## **NGUYEN PLACE SUBDIVISION**

Engineering Comments: FINAL PLAT COMMENTS (should be addressed prior to submitting the FINAL PLAT for review and/or signature by the City Engineer):

***Revised for the April 20<sup>th</sup> meeting:***

# DETAIL SITE PLAN

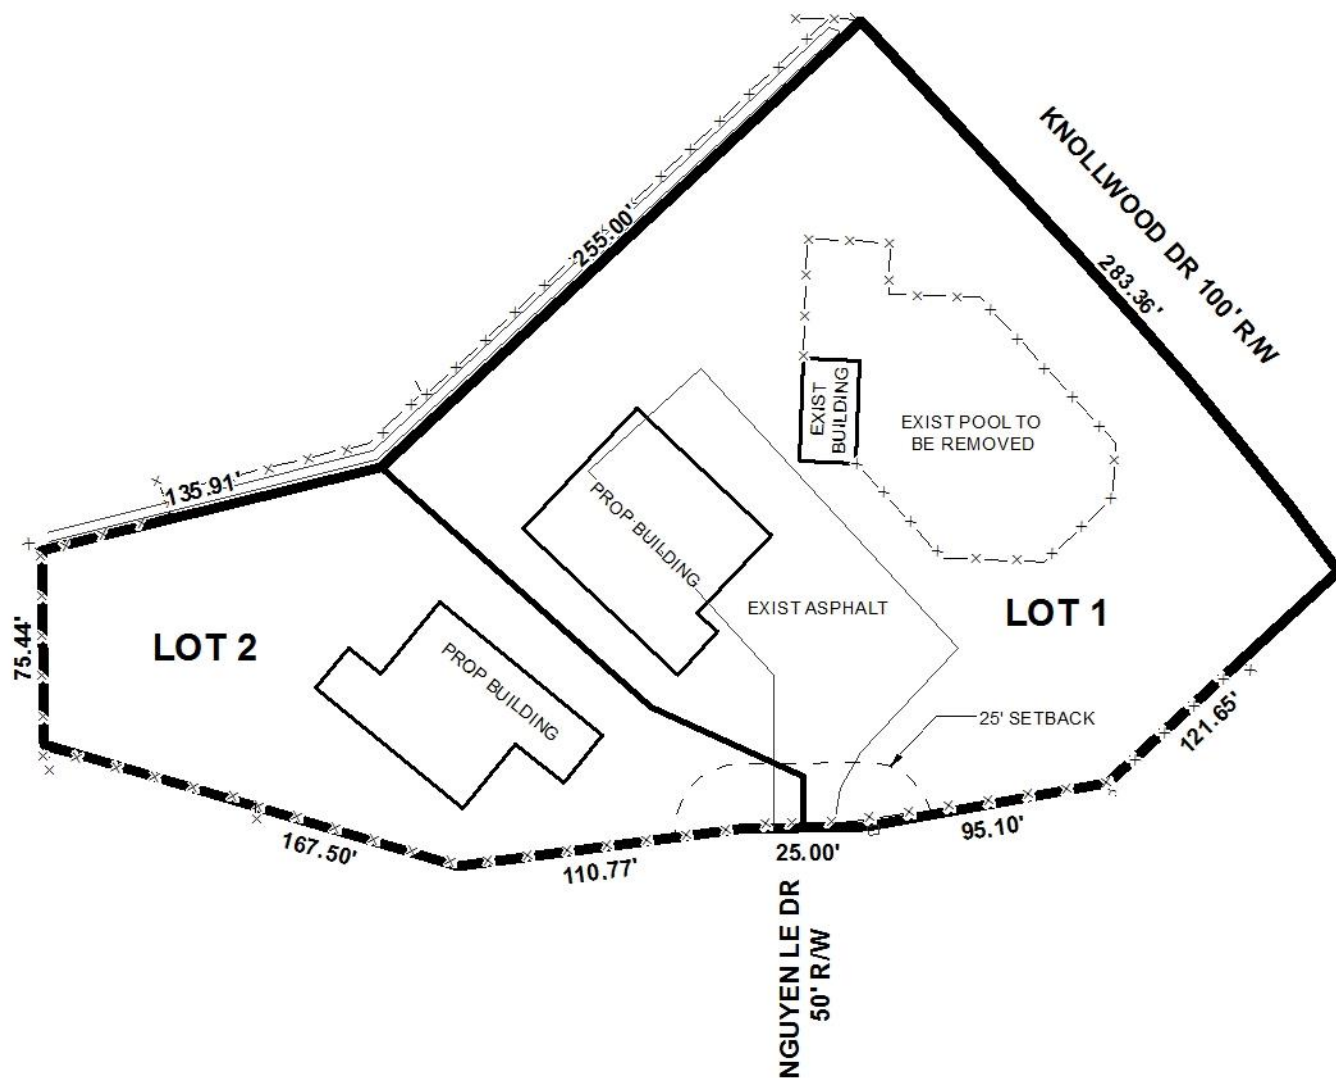
The 25-foot minimum building setback is also illustrated on the preliminary plat along Nguyen Le Drive, but not along Knollwood Drive. As such, revision of the plat to illustrate the 25' minimum building setback line along all street frontages should be required, if approved.

Finally, the site abuts Amberly Subdivision, Unit 1, to the South, and Amberly Subdivision, Unit 1-A, to the North, plats for which were recorded in Mobile County Probate Court on March 6, 1974 and June 5, 1975, respectively. Lots abutting the South property line of the subject site illustrate 7.5' drainage and utility easements; and, 15' drainage and utility easements are illustrated where lots abut the North property line of the subject site. Staff has verified that no vacations of said easements have been granted by the City Clerk's office; therefore, the plat should be revised to illustrate 15' and 7.5' drainage and utility easements along the North and South property lines, respectively, if approved. Also, if approved, a note should be placed on the Final Plat stating no structures will be constructed in any easement.

No revised plat illustrating any drainage easements was submitted to Staff; however, staff still requests the provision on 7.5' drainage easements on the Final Plat along the West and South lot lines.

- 4) revision of the plat to illustrate the 25' minimum building setback line along all street frontages;
- 5) revision of the plat to illustrate the 7.5' drainage and utility easement along the South property line of each lot, and the West property line of Lot 2;

- 6) placement of a note on the Final Plat stating no structures will be constructed in any easement;
- 7) compliance with Engineering comments: (FINAL PLAT COMMENTS (should be addressed prior to submitting the FINAL PLAT for review and/or signature by the City Engineer): A) Provide all of the required information on the SUBDIVISION PLAT (i.e. signature blocks, signatures, certification statements, written legal description, required notes, legend, scale, bearings and distances) that is required by the current Alabama State Board of Licensure for Professional Engineers and Land Surveyors. B) Add street names to the vicinity map, especially the ones shown on the plat. C) Review and revise the written legal description to match the reference to the page number shown in the description of the Point of Beginning. D) Show and label each and every Right-Of-Way and easement. E) Provide and label the monument set or found at each subdivision corner. F) Add a signature block for the Owner, Notary Public, Planning Commission,
